RE: DRAINAGE COMPLIANCE @ 1721 VALDEZ NE (J23-D19)

RE: DRAINAGE PLAN FOR A RESIDENCE @ 1721 VALDEZ, NE
(J-23/D19) REBONITO SUBDIVISION, BLOCK 2, LOT 4
ENGINEER'S STAMP DATED JUNE 18, 1992

DRAINAGE PLAN
FOR HOUSE LOCATED AT
1721 VALDEZ DRIVE N.E.
ALBUQUERQUE, NEW MEXICO
JUNE, 1992

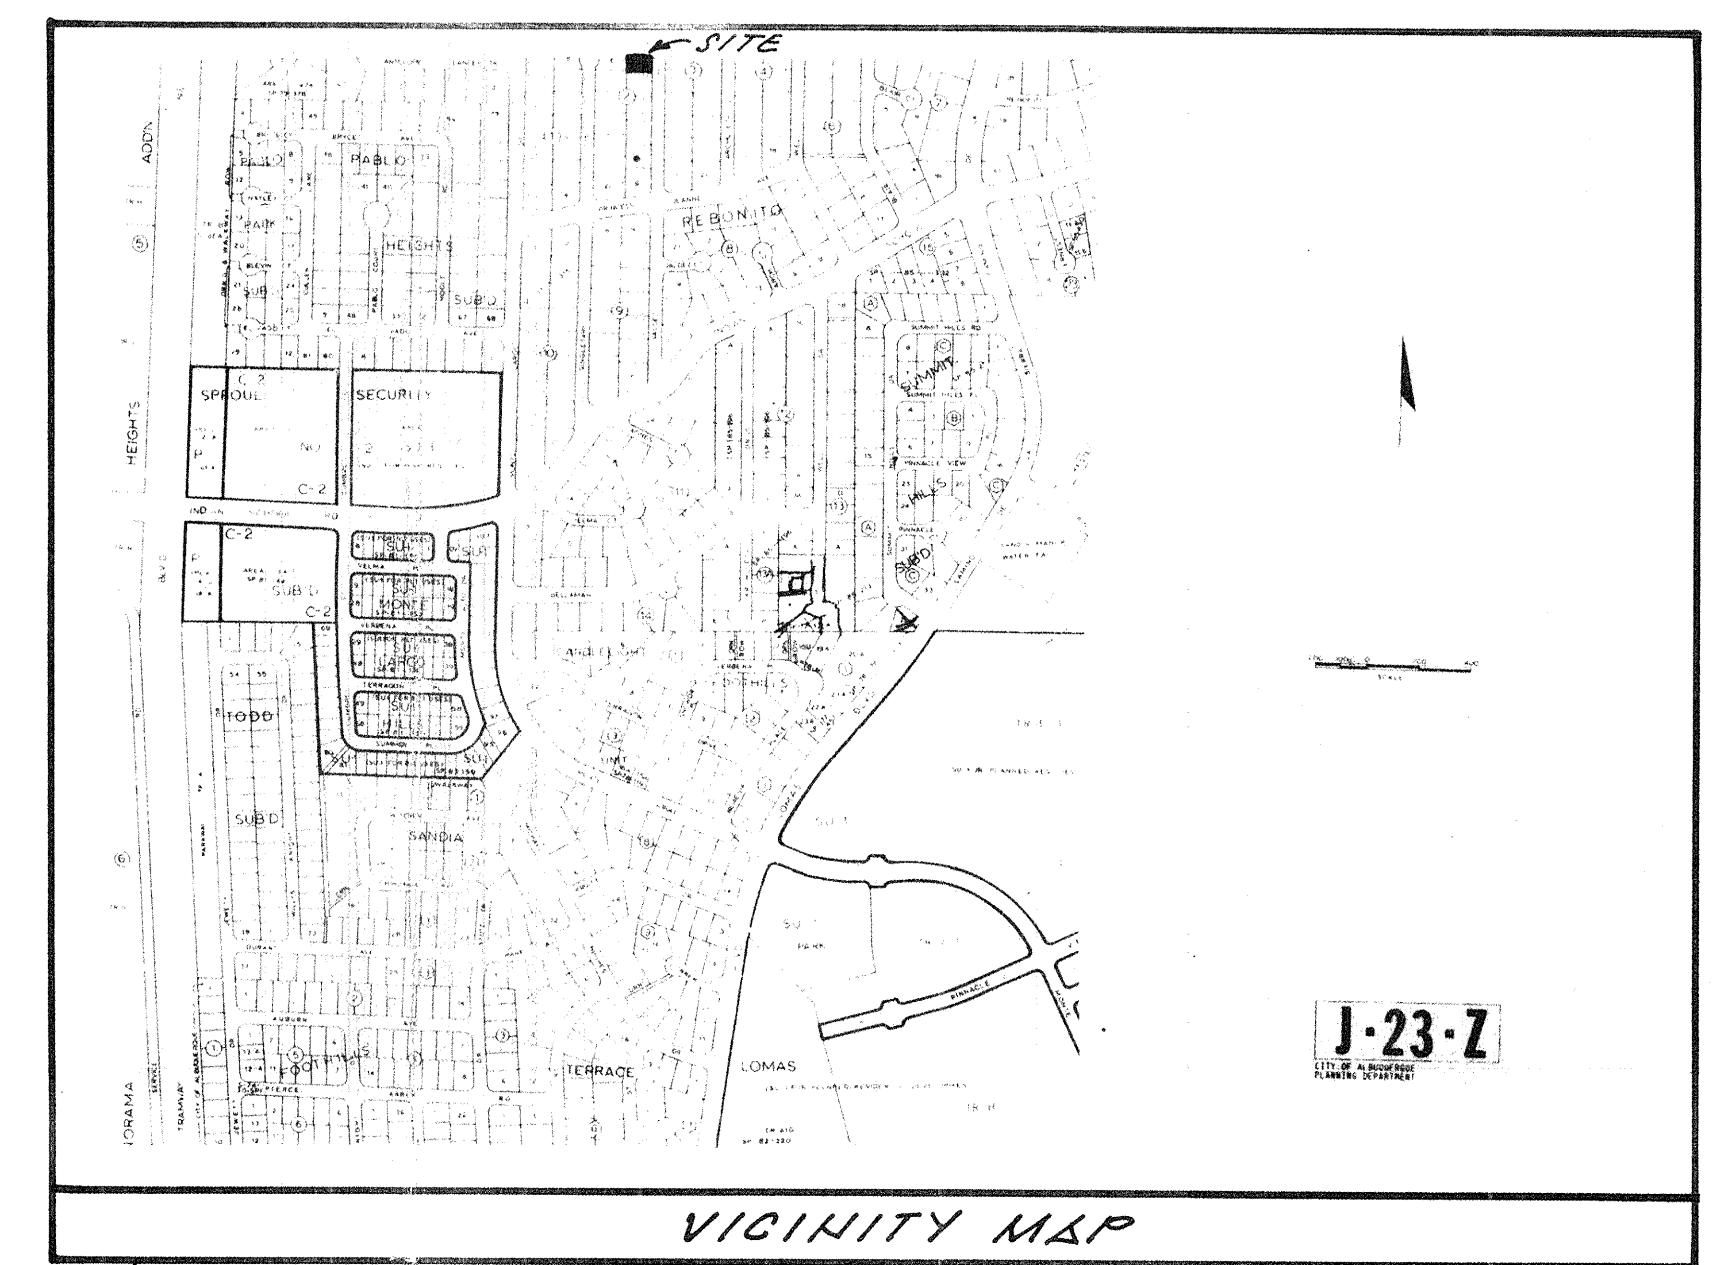
Based on the field inspection conducted on March 10, 1995, changes to the drainage concept as discussed and constructed are acceptable.

The changes discussed with you in our field meeting on February 28, 1995 are listed below:

1. Guttering the rear porch canals toward the southwest corner of the house and exiting down towards the street, thus eliminating the need for the ponding area on the top terrace.
2. Digging the inside corner of the cinder block wall where it meets the retaining wall and installing an impervious membrane to eliminate the possibility of undermining.
3. Installation of the small retaining wall at the far northwest corner of the property.

If some unforeseen reason the undermining still occurs, other precautions may need to be implemented.
